TECHNICAL MEMORANDUM

Review of DRAFT: Investigation of Ground Water Contamination near Pavillion Wyoming
Prepared by the Environmental Protection Agency, Ada OK

Prepared by: Tom Myers, Ph.D.
Hydrologic Consultant
Reno NV

Figure 1: Snapshot from EPA (2011) Figure 3 showing frequency of depth for gas wells (top), surface casing for gas wells, and base of domestic wells.

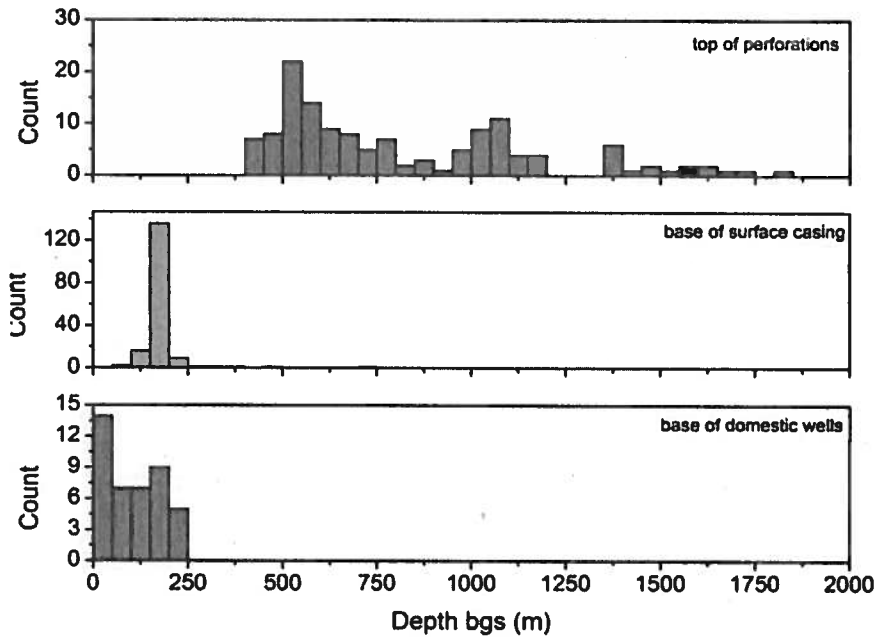
EPA established two dedicated monitoring wells to supplement the data obtained from the water wells. The new monitoring wells were primarily screened below the level of the water wells (Figure 1) and above the gas production wells to "differentiate potential deep (e.g., gas production related) versus shallow (e.g., pits) sources of groundwater contamination" (EPA p 5). The EPA established just two monitoring wells due to a limited budget (Id.). EPA placed the monitoring wells' screened interval along the conceptualized vertical pathway between the potential contaminant source (i.e. the production wells and/or zone) and the water wells. The monitoring wells were designed appropriately to detect and monitor contaminant movement upward from the production zone to the water wells; if the monitoring wells had been constructed at the same depth as the water wells, they would not have added substantial useful information.

Figure 1 (EPA Figure 3) shows that domestic water wells in the regions are screened at all levels down to about 250 m, or more than 800 feet, with half of the wells being deeper than 300 feet, similar to the depths found by Daddow (1996) in other areas of the aquifer. However, the EPA states the information source was from the State Engineer *and* homeowner interviews (EPA p 2). It is unclear whether both were used for each well. It is my experience that homeowners have a poor concept of the depth of their well unless they have paperwork that documents it.

Recommendation: The EPA should provide more information about the source of its water well construction data, showing it in EPA Table A1.
